ADDENDUM NO. 2

August 7, 2026

Perry Township Schools:
Southport High School Addition & Renovation Phase 2 (Classroom Addition and Athletic Renovations)
971 E. Banta Road
Indianapolis, IN 46227

Phase 2: ADDENDUM NO. 2 (TWO)

T101L

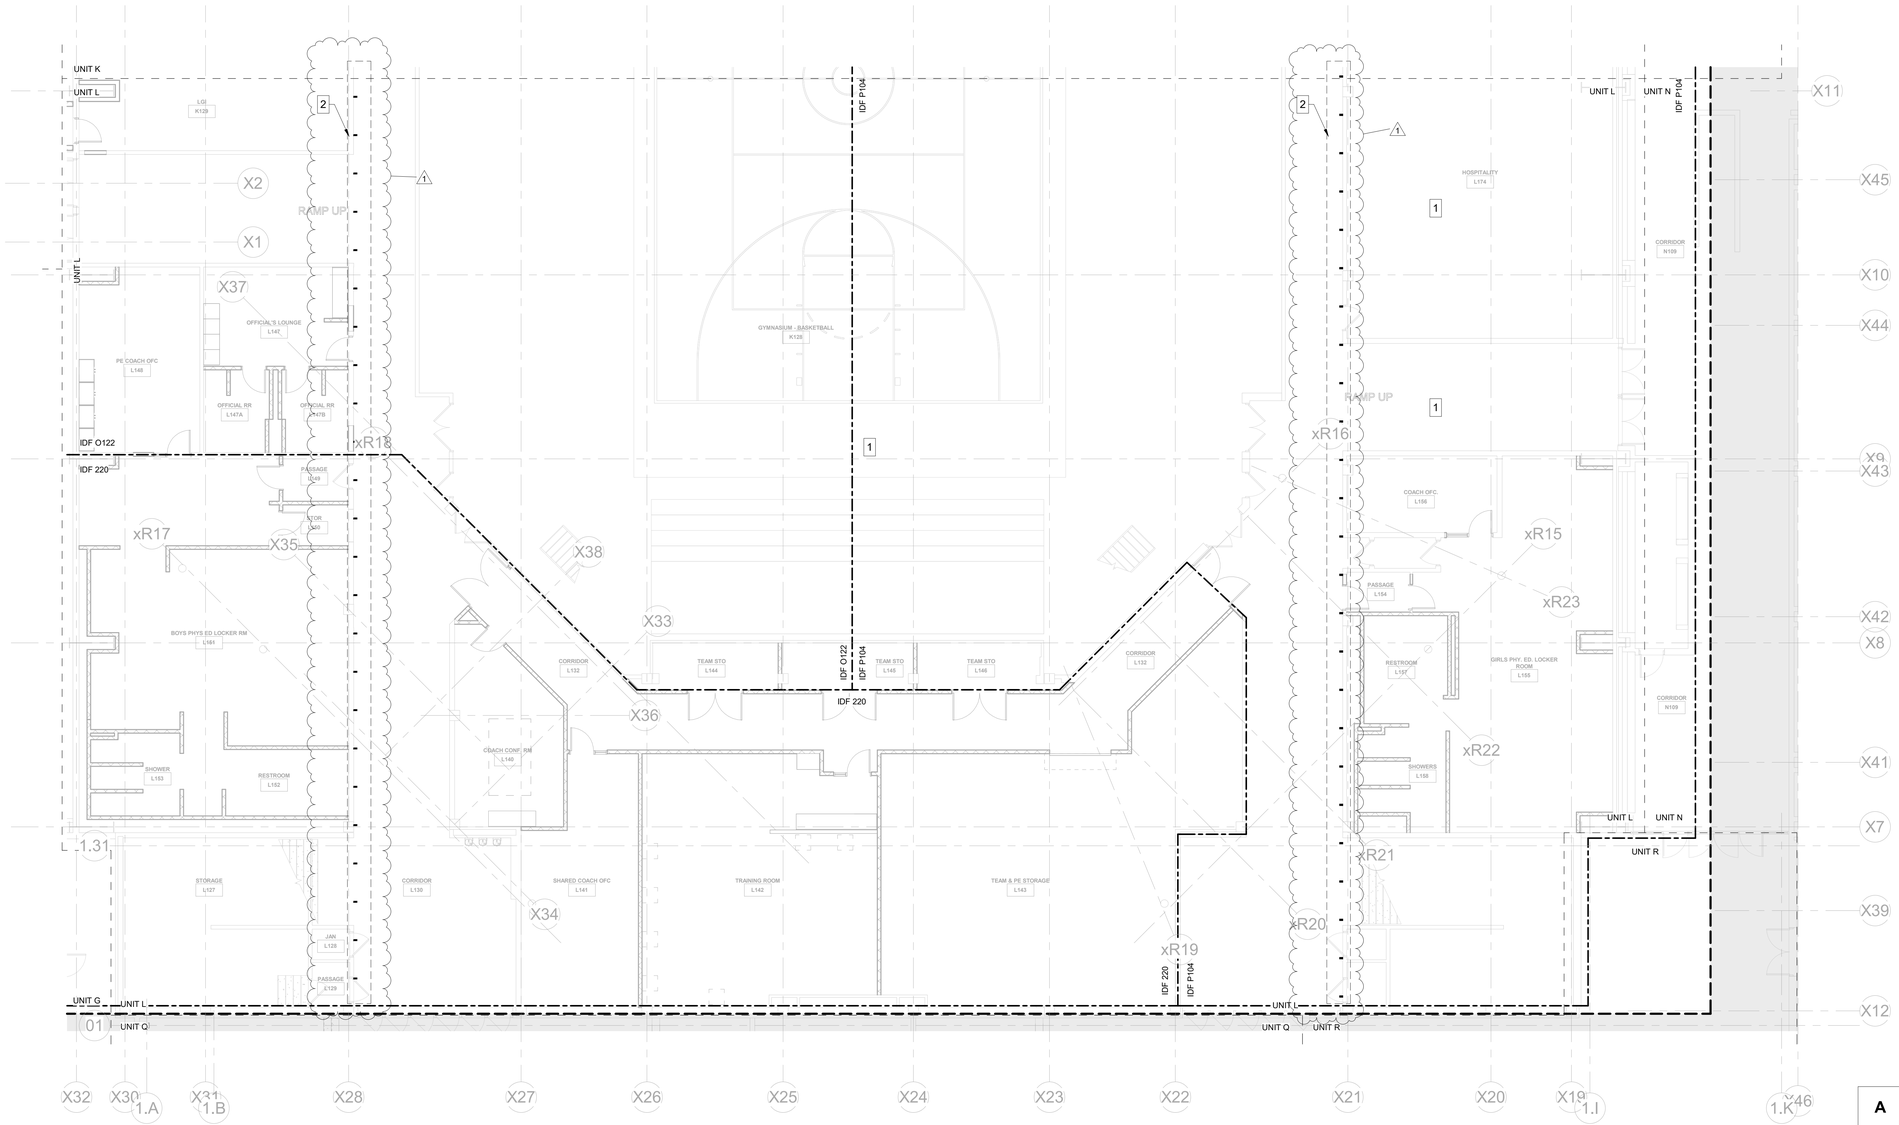
35. Drawing Number: T101L
    Drawing Title: FIRST FLOOR DISTRIBUTION PLAN – UNIT L

Change: Added scope
    - Added J Hooks in existing fieldhouse side corridors
    - Added sheet note #2

AV DIAGRAMS

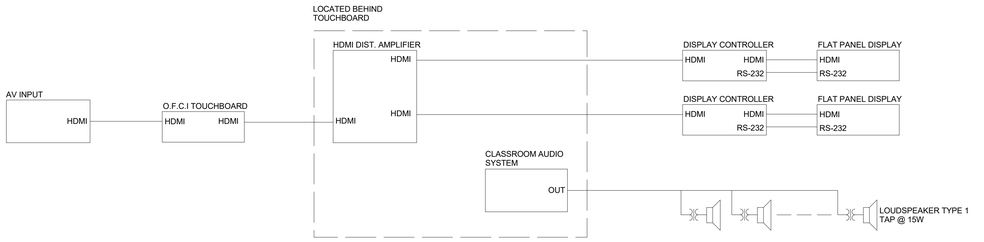
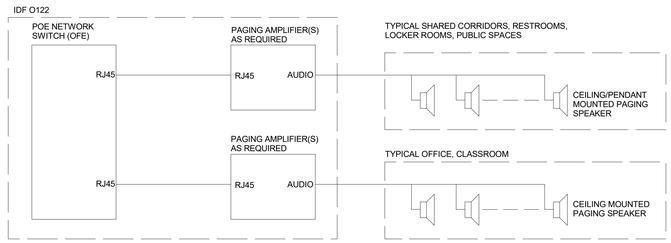
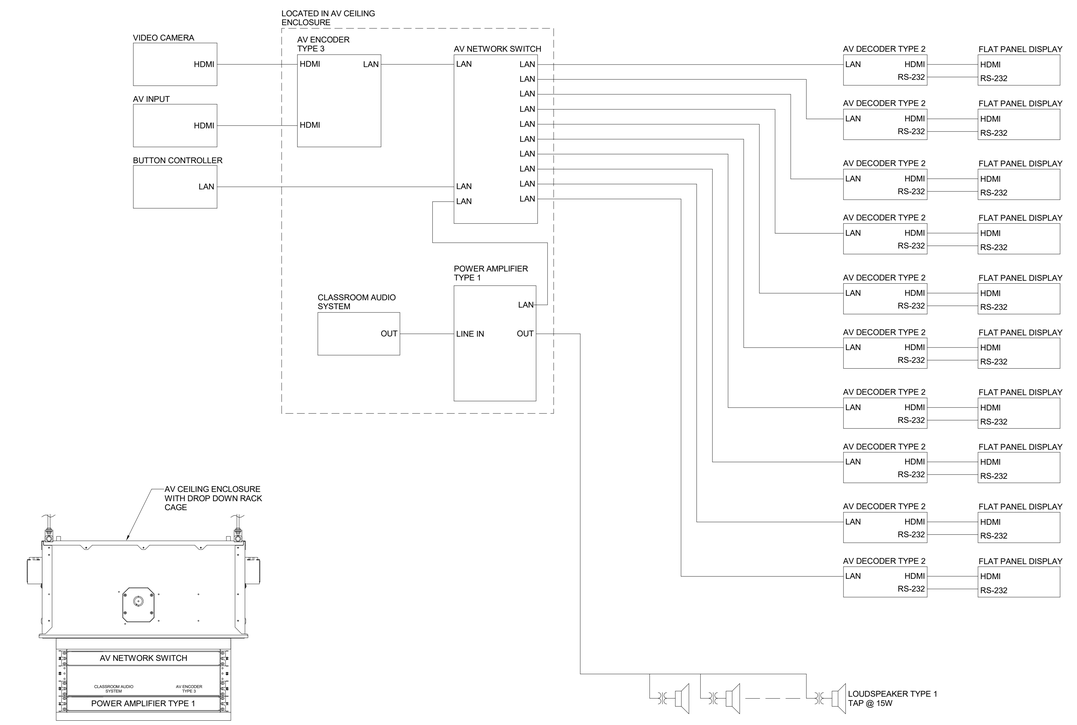
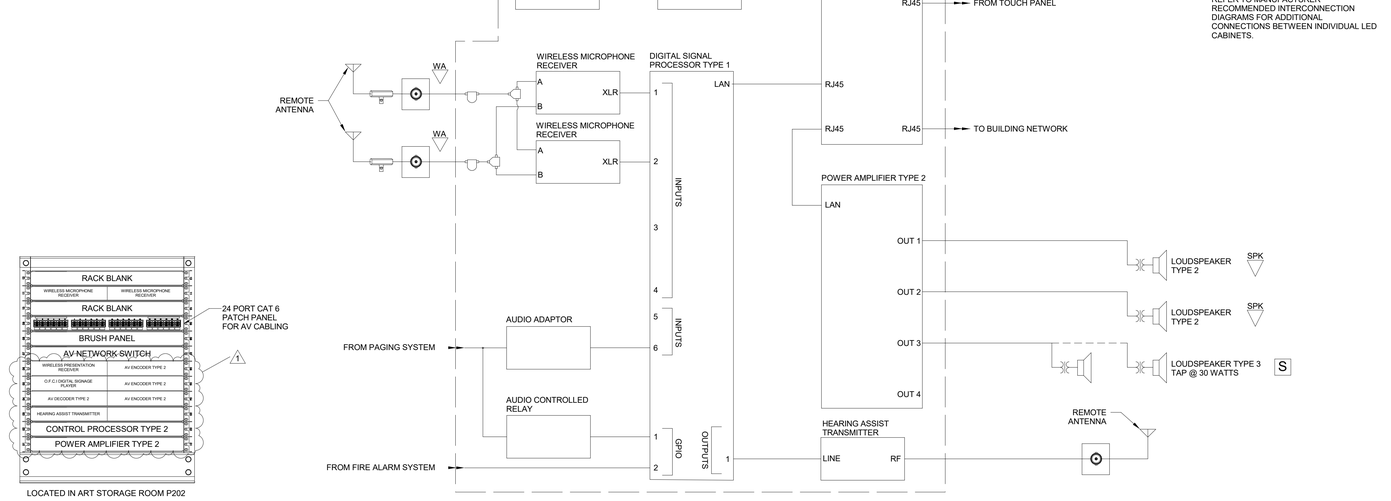
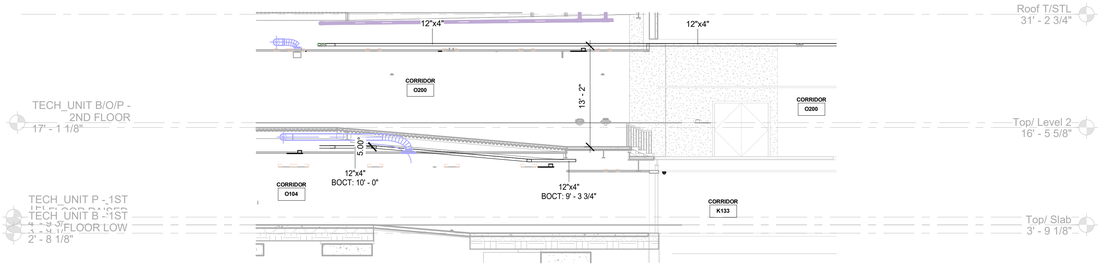
36. Drawing Number: T305
    Drawing Title: AV DIAGRAMS

Change: Revised control processor in Lobby AV system
    - Revised diagram #9 to modify Control Processor Type and connectivity
    - Revised detail #8 to show control processor

6 FIELDHOUSE TO FIRST FLOOR
CORRIDOR - SECTION VIEW
1/4" = 1'-0"

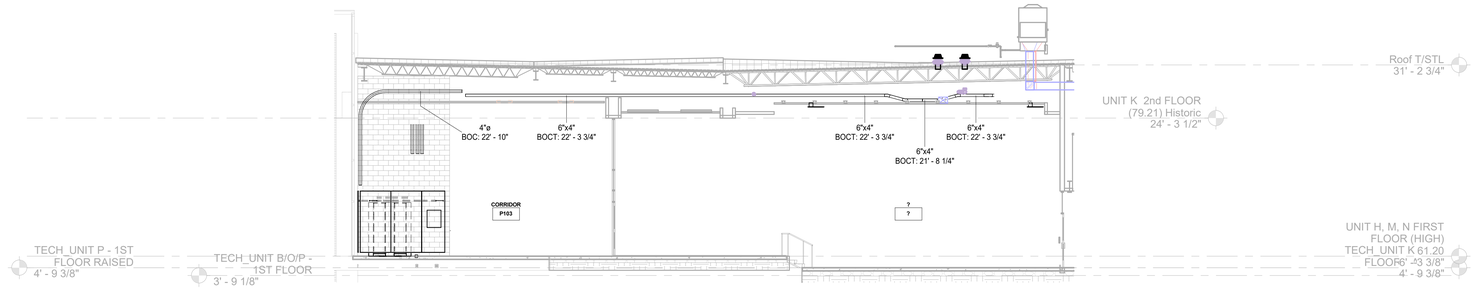
37. Drawing Number: T308
    Drawing Title: DISTRIBUTION SECTIONS

Change: Added view
    - Added view #6
